EXAR CORPORATION		
XRT91L80 - Interface & Control		
Size C	Document Number OC48 TRANSCEIVER	Rev 0
Date: Tuesday, July 25, 2006	Sheet 1 of 2

EXAR CORPORATION		
Title XRT91L80 Power Distribution		
Size C	Document Number OC48 TRANSCEIVER	Rev 0
Date: Wednesday, July 19, 2006	Sheet 2 of 2

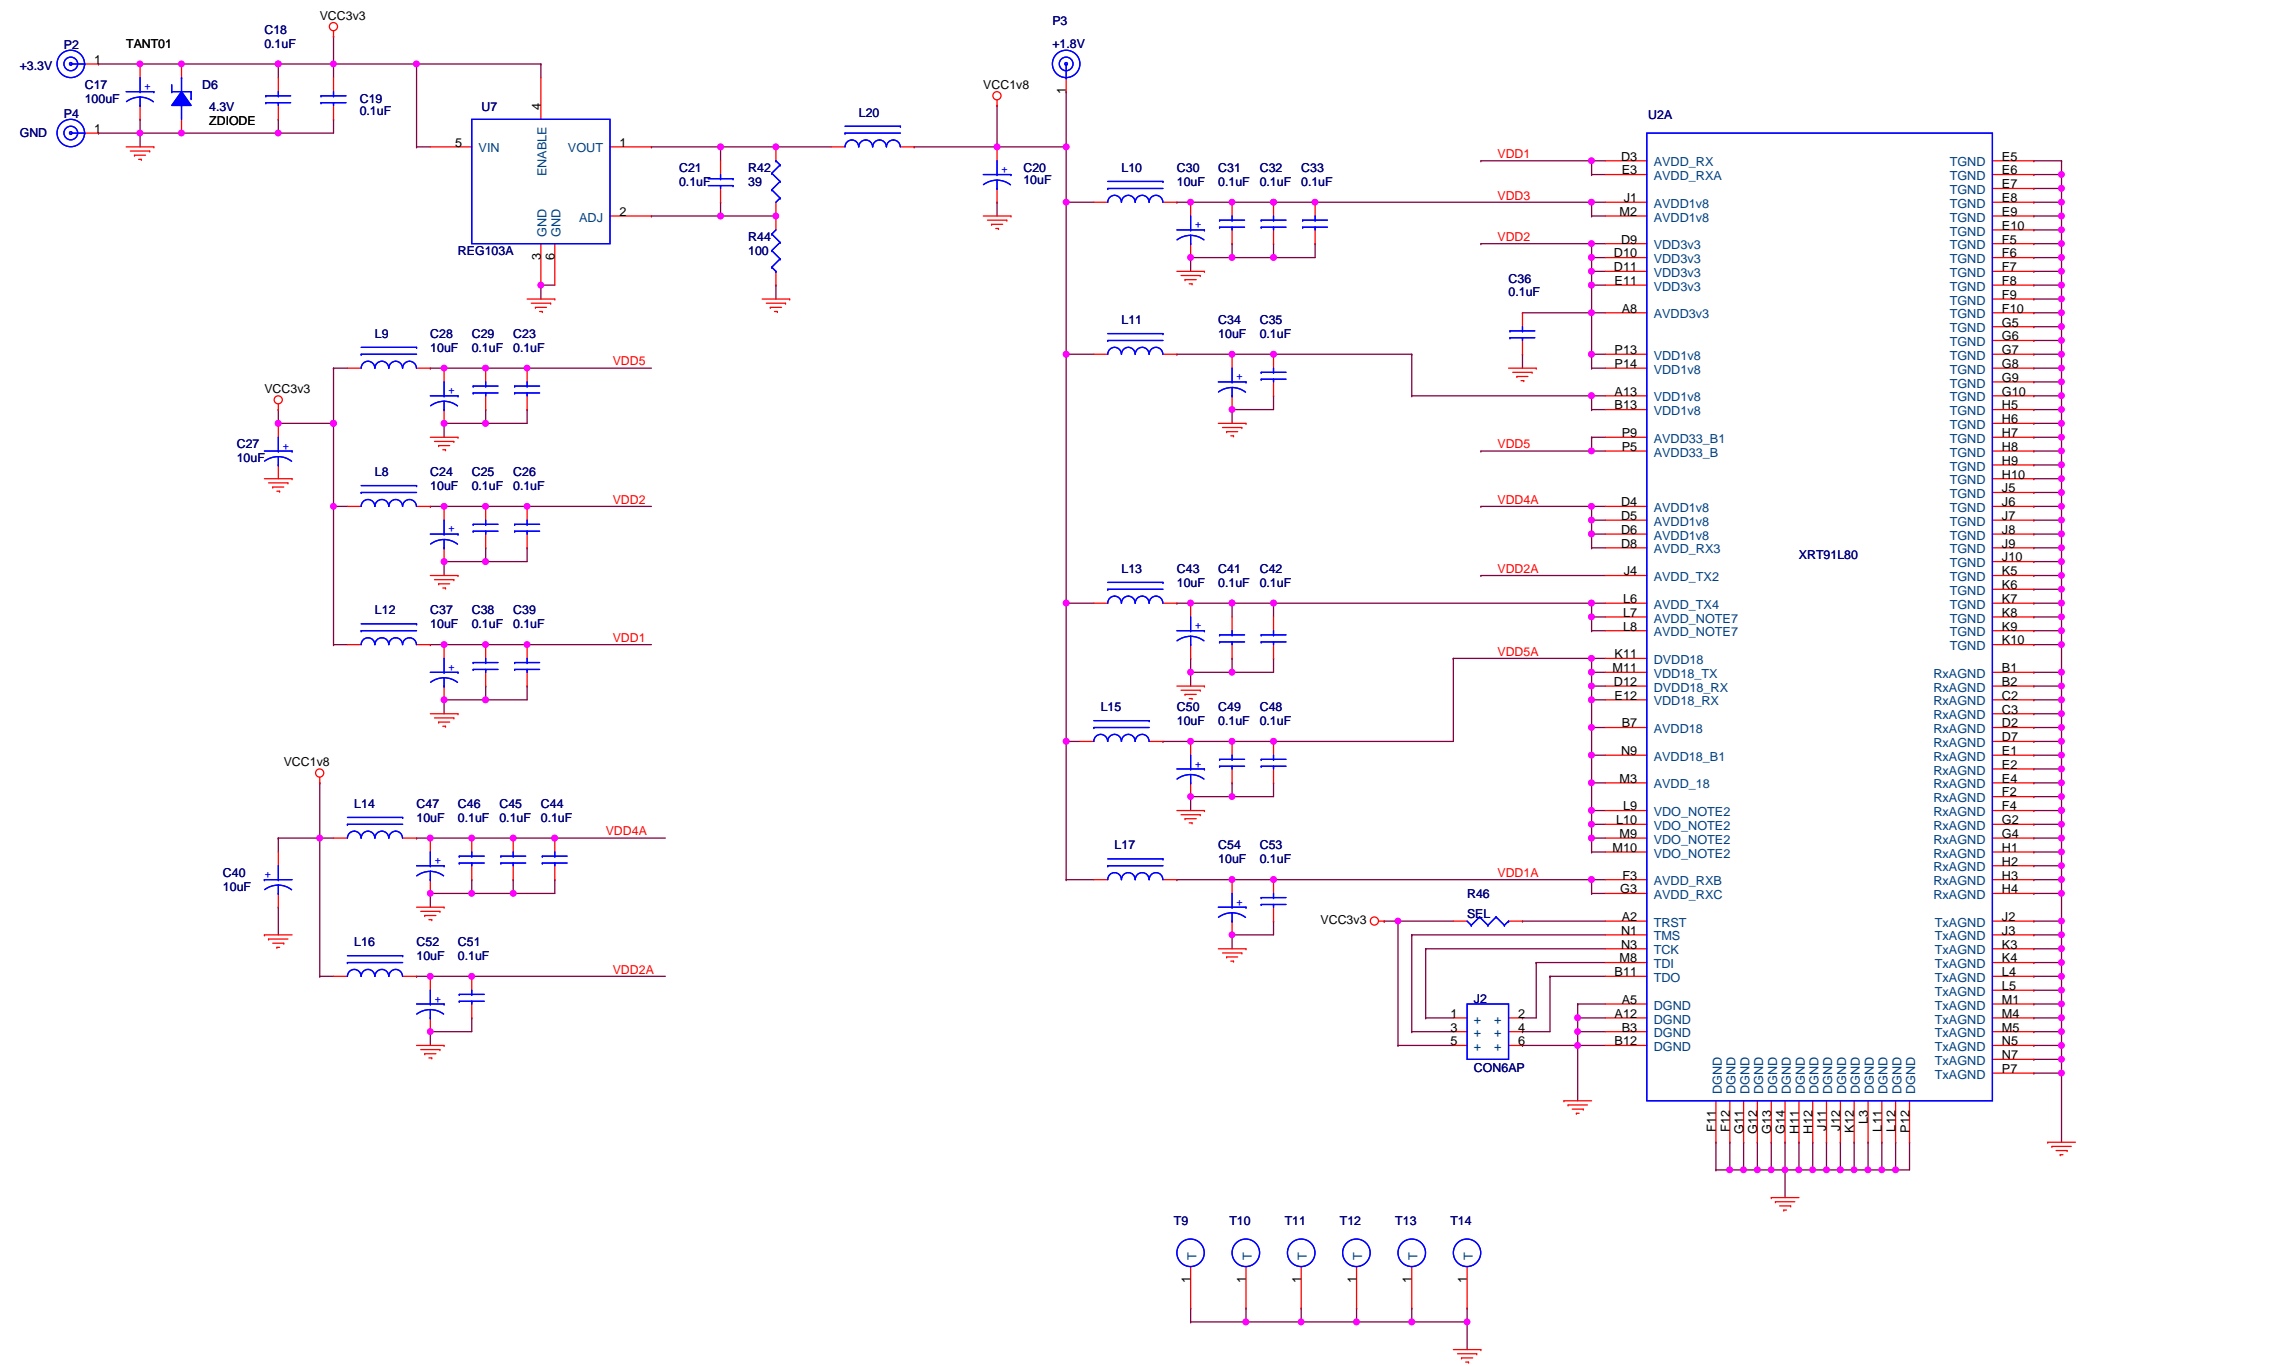
Changed make From Rev C to D :
 1 Adding USB section .
 2 Change power supply pin P13 & P14 from 1.8v to 3.3v
 3 Change resistors size to be smaller and closer to the pins R20, R21, R22, R23, R24, R37 and R45
